Z-88  
(2015)

Blackwell Preserve Unit Two  
Preliminary Subdivision Layout  
Lots 307, 308, 341 & 342  
16th District 2nd Section  
Cobb County Georgia  
Field Book Aug. 9, 2015  
Plat & Master Aug. 6, 2015  
Scale: 1"=300'

**PETITION NO:** Z-88

**ZONING COMMENTS:**

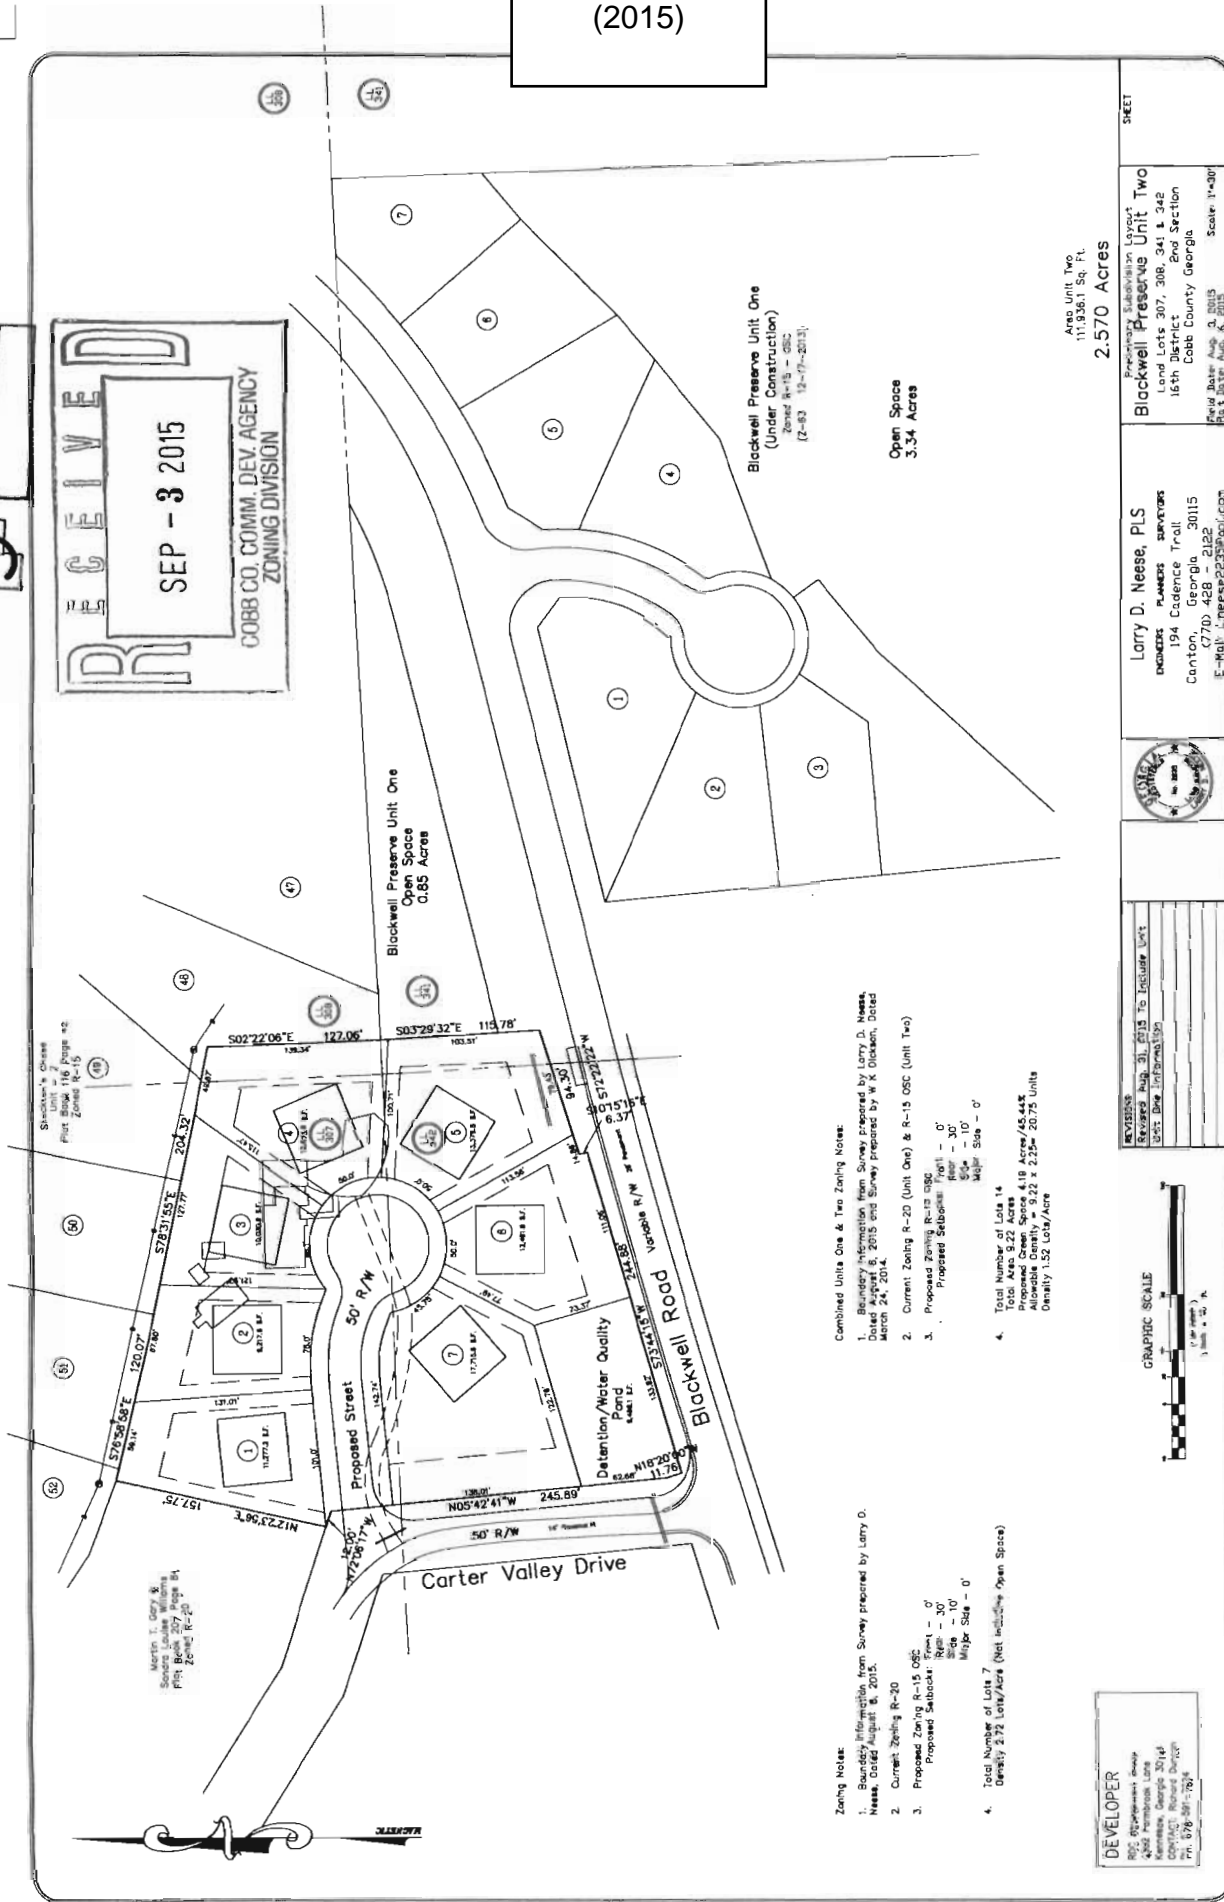
1. Need to make note on site plan whether or not Floodplain/wetlands/Lakes are present on both tracts of land that includes Unit 1 and Unit 2.
2. Contiguity of open space is highly desirable.

5. Need to provide either a 25 foot dedicated open space strip or a 15 foot pedestrian easement to access contiguous open space.
6. Please list lot sizes for adjacent compatibility purposes.

7. For all lots setbacks should meet or exceed that of the underlying zoning.
8. Must have Cobb Department of Transportation approved lighting plan in if outdoor lighting (except individual residential lots) is proposed

- No Stormwater controls shown \_\_\_\_\_
- Copy of survey is not current – Additional comments may be forthcoming when current site conditions are exposed.
- No site improvements showing on exhibit.

1. The entire site drains to the west through the Rock Garden Subdivision into the floodplain of Rubes Creek via a small private farm pond within the Rock Garden Subdivision. A hydrologic routing will be required to verify no adverse impact to this pond. A pre- and post- sediment survey will also be required.
2. A 20-foot drainage easement and adequate pipe capacity must be provided at the rear of lots 5 and 6 to convey offsite runoff through the site.
